Design Officer	Azhar Kapadi
Date	14.03.25
Application Reference	24/01262/FUL
Address	Village Hotel Bury, Waterfold Business Park, Rochdale Rd, Bury BL9 7BQ
Proposal	Erection of a 34-bedroom extension to existing hotel and associated works

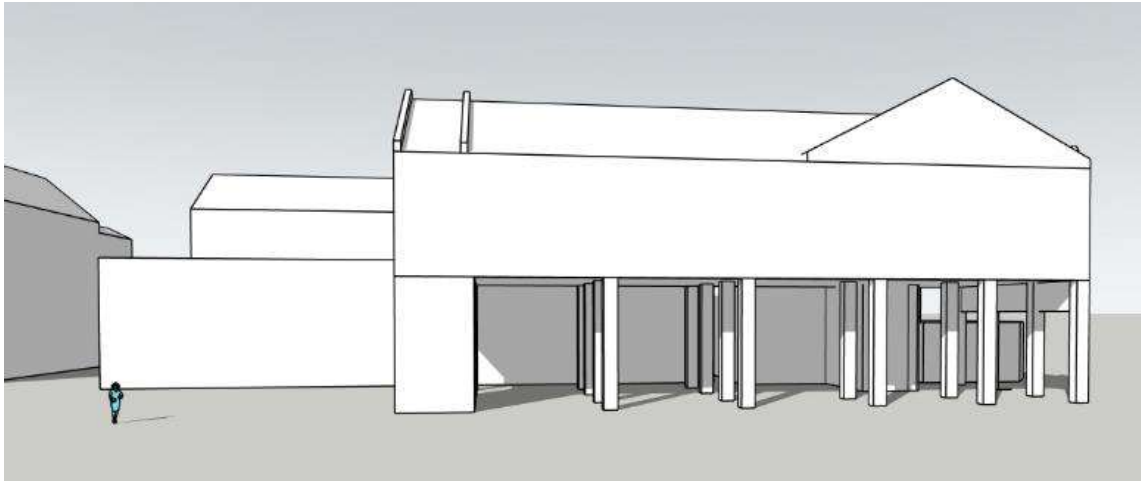
The building footprint has increased with the capacity increasing from 27 beds to 34. The design and massing of the extension has however been poorly compromised in order to accommodate this. It was considered at that time, monotonous elevations needed to be improved and the building footprint should move inwards from the site boundary and maintain the tree/ landscaped buffer to the neighbouring site. The design statement has highlighted design related comments I made but very little has been done to address them.

Elevation B (previously elevation C at pre-app) no longer is a gable end but is now more overbearing than previously shown. This is a dominant and visually weak elevation made worse by the removal of the tree lined boundary and I am failing to see this is a visual improvement.

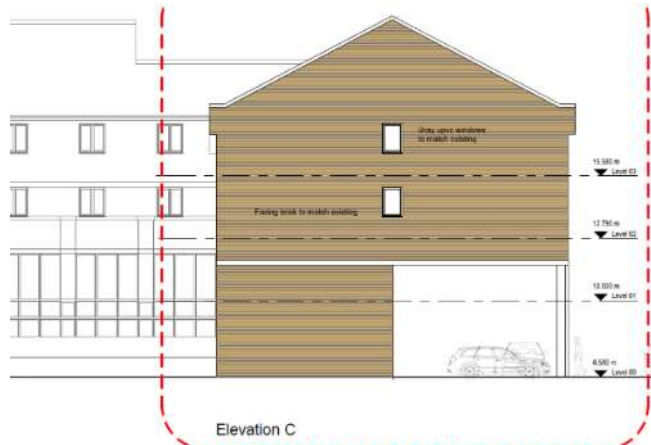
Elevation B is overly dominating, characterised by unsightly large columns that are no longer screened

Due to a lack of articulation and detail, the elevations look something more reminiscent of poor student housing scheme or a prison building. Refer back to preapp comments on how to improve this.

Elevation 'A'

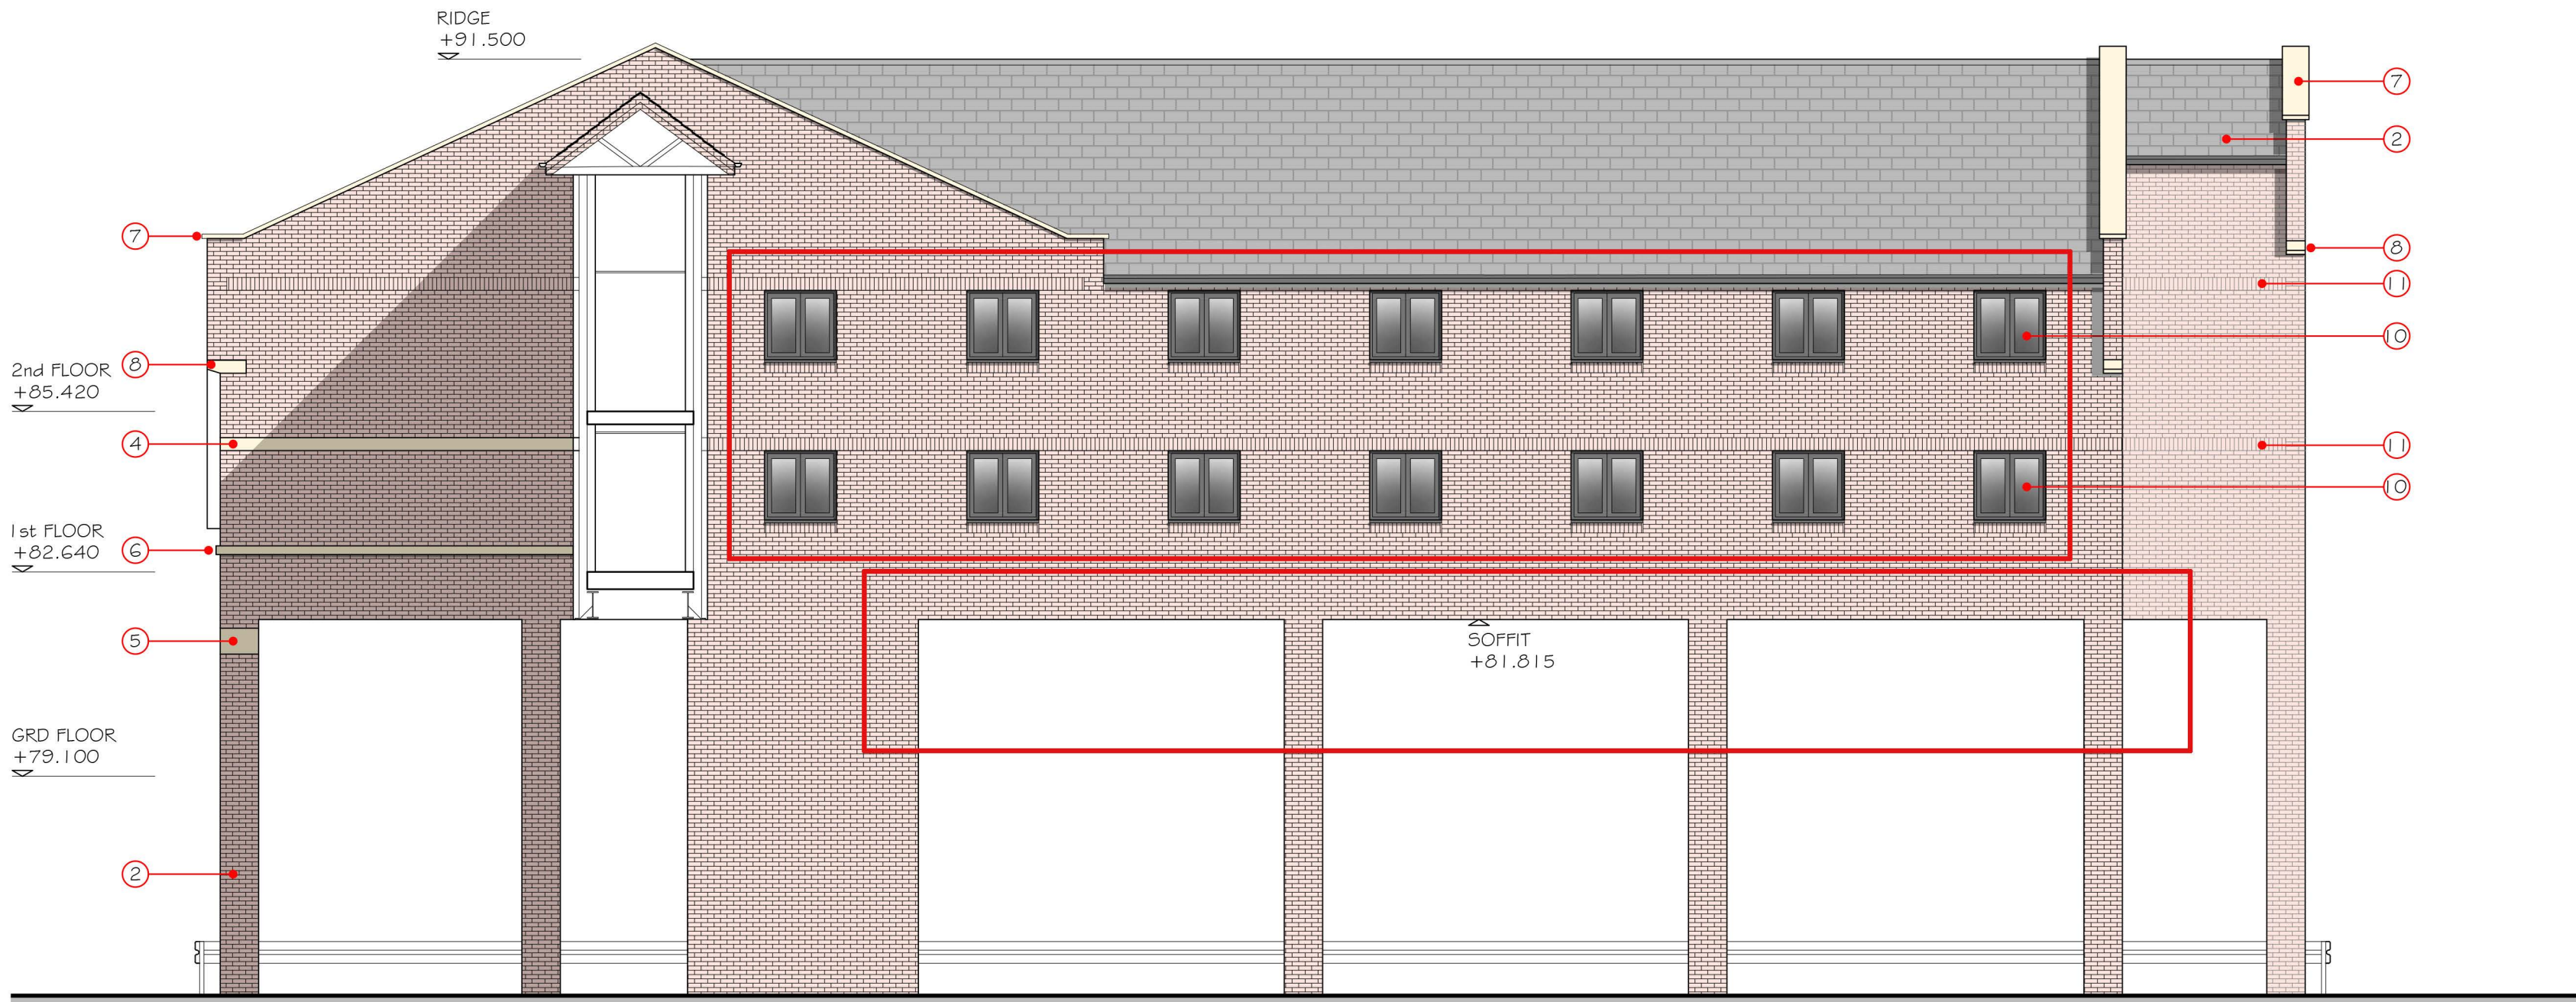
In the proposal, the existing façade continuation now introduces a break disrupting the overall elevation. Additional architectural details are needed to soften the area dominated by columns. Simple architectural details can easily be introduced to the front elevation whereas the approach to the side /rear elevations appear represent a particularly poor design response. Thankfully, the existing elevation has some design features which the designer has largely employed but as the elevations turn the corner, any appreciation for visual amenity has been forsaken. These elevations in particular are not harmonious and do not positively improve the surroundings.

Drawing remains copyright of the designer. Amendments made by AK are purely for informative purposes
